From: Anita Gardner <Anita.Gardner@arun.gov.uk>
Sent: 21 July 2020 08:27
To: Planning.Responses <Planning.Responses@arun.gov.uk>
Subject: FW: AB/49/20/L Objection

Subject: RE: AB/49/20/L Objection

Sent: 09 July 2020 17:35
To: 'Andrew Wood' <Andrew.Wood@arun.gov.uk>
Cc: 'Juan Baeza' <Juan.Baeza@arun.gov.uk>
Subject: AB/49/20/L Objection

Structural Engineers Report by Philip Goacher Associates

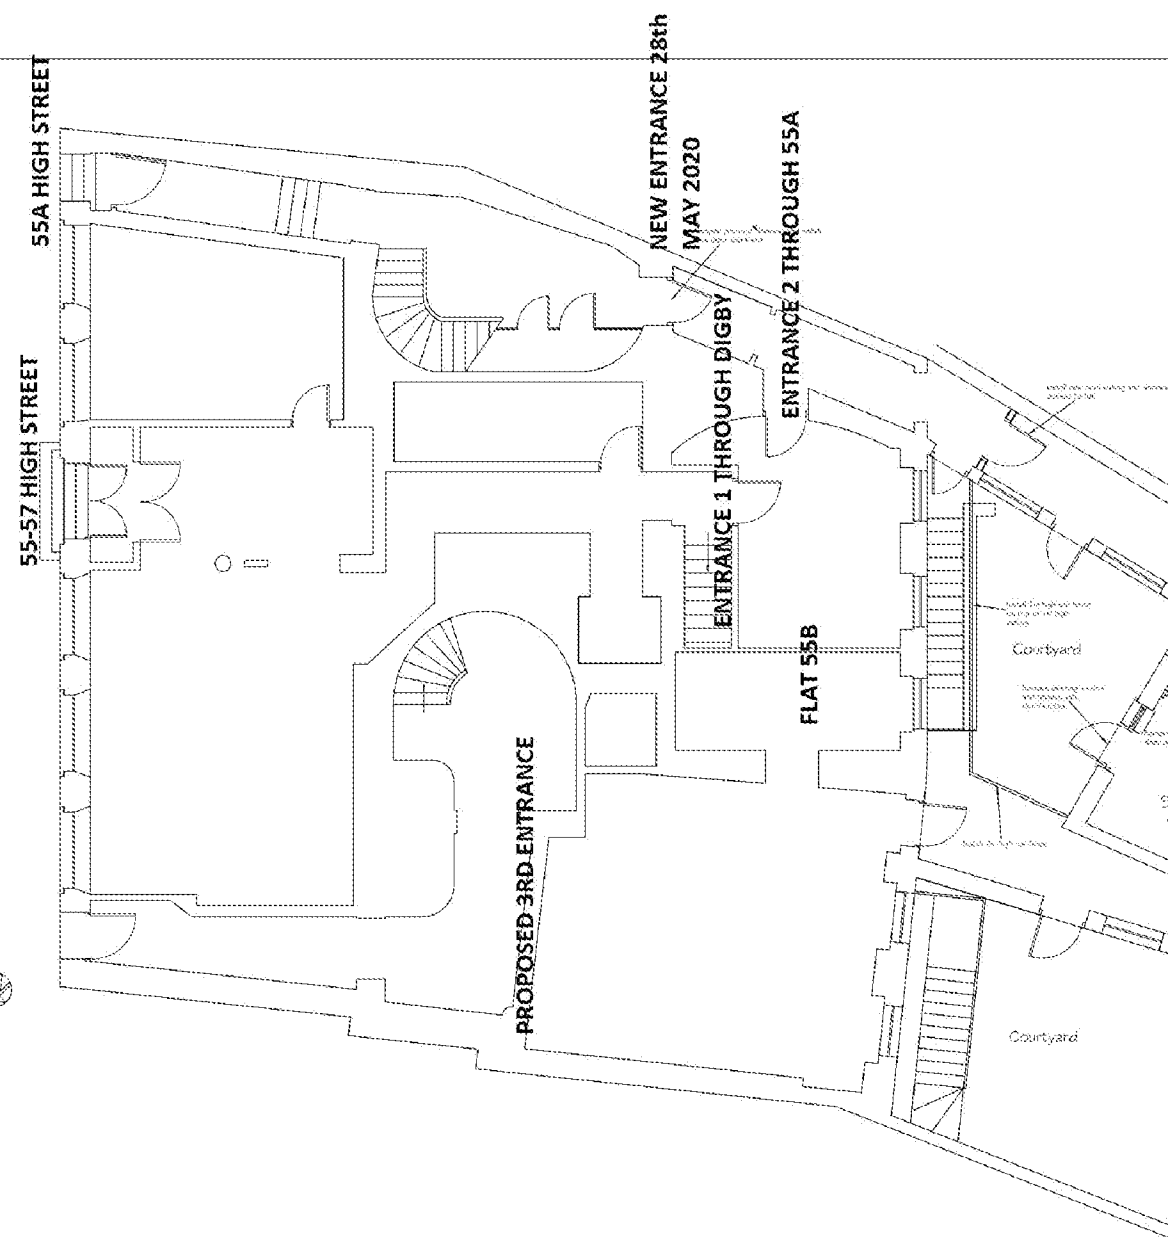
It is stated in their report that it is “conservatively assumed” that “the internal wall , where the new opening is proposed, is continuous from the ground floor up to the roof level.” **This assumption is incorrect.** The wall has already been knocked through at the first and second floors. Further, the structural engineer did not even attempt to notify me of his visit or make an appointment with me to view my flat or the flat above and has disregarded the works and issues that have occurred in the communal area of 55A (the same building). As a result, I have asked for a copy of their insurances but they have refused to provide these to me.
